RIVERSIDE COUNTY
PLANNING DEPARTMENT

RE: CONDITIONAL USE PERMIT NO. 230002 "Crescent Gardens Cemetery"

REQUEST: Conditional Use Permit No. 230002 is a proposal for the construction of a cemetery (25 acres of gravesite), mortuary, chapel, equipment shed, and caretaker manager residence.

Your proposal was scheduled for comments from the Development Advisory Committee (DAC) on **October 17, 2024.** Enclosed are the resulting comments from the Riverside County Planning Department and all other available comments and recommended Conditions of Approval.

Schedule

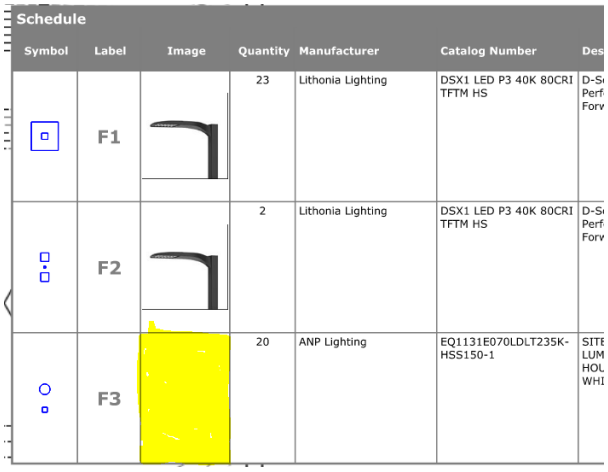
7. **Repeat Correction**: Provide a visual example of the F3 lighting proposed on-site so it can be verified that it's meeting lighting standards.
